To All Lamborghini Dealers and Licensed Service Point
From Customer Service Department
Subject Engine bonnet release cable routing
Group LB715.8.03
Attachments -
Date 16.10.2006
Pages 5

Engine bonnet release cable routing

All MY06 Gallardo Spyder from VIN G64126 to VIN G74360.

Pict. 2

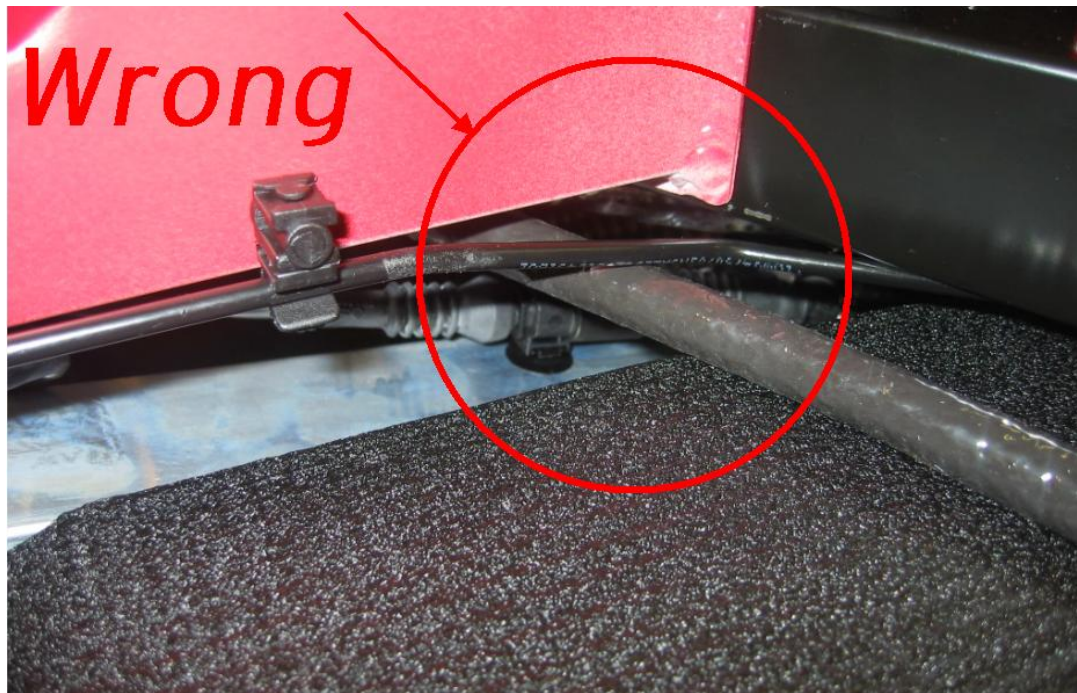
The heat from the exhaust box could fuse the opening cable so it is necessary to check the routing of the cable.

- 1.3 The cable should not be in contact with the exhaust box, the wrong routing is shown in picture 2 and the correct routing in picture 3.

1.4 If the routing of the cable is not correct as shown in picture 2, please change the routing.

- 1.5 Disassemble the cable from the bonnet lock using a screwdriver to disconnect the hook, as in Pict. 4. Then change the routing of the cable.
- 1.6 In order to change the routing it is not necessary to disassemble any parts, you have only to push carefully the cable under the mudguard and put it upon the black pipe as shown in picture 3.
- 1.7 Then connect the cable to the lock.
